19 January 2017

WALLARAH 2 COAL PROJECT – RESPONSE TO DPI – WATER QUERIES

Figure 1 - Time series of simulated flow at Lower Wyong River Weir for 2009

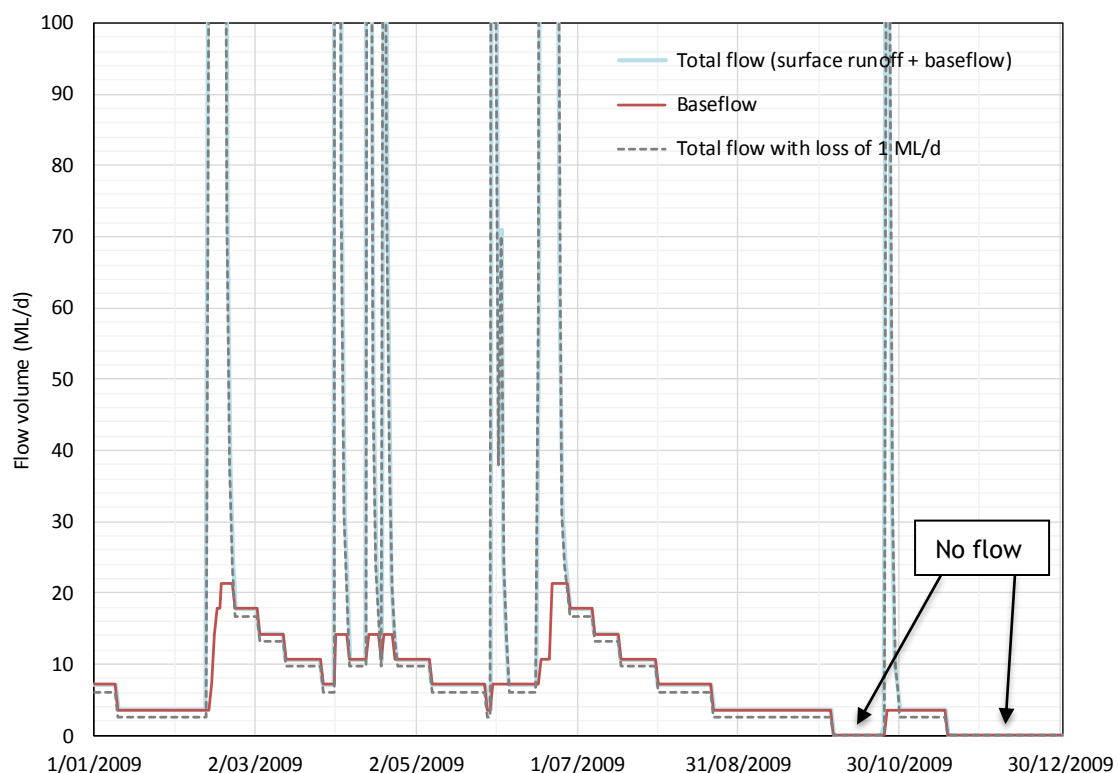
In response to the above, the Proponent has provided a table with estimated losses by year. However, it is not clear how these figures have been derived. The Proponent should provide detailed responses to each of the PAC recommendations outlined above from (a) through (e). Any modelling and data used in the determination of any figures presented should be provided for review.

Figure 1 shows the simulated time series of daily total flow volume at Lower Wyong River Weir for the two modelled scenarios for 2009.

- Surface runoff = 8,848 ML (77%);
- Baseflow = 2,588 ML (23%);
- Total flow (surface runoff plus baseflow) = 11,436 ML;
- Volumetric runoff coefficient = 4% (compared to average of 17% for Wyong River and 24% for Jilliby Jilliby Creek).

Including the daily flow loss, the total flow volume reduces to 11,134 ML; a reduction of 2.6%.

The impact on flows is negligible during periods of surface runoff.

The impact of flow loss during dry periods (eg. January, March, May and July-September in 2009) is apparent, but does not change the general character of flow which typically persists for an extended period after surface runoff, with some no-flow periods after extended dry weather. Within the resolution of the model, the impact on the number of no-flow days is negligible. In practical terms, it is unlikely that this flow volume loss could be detected.
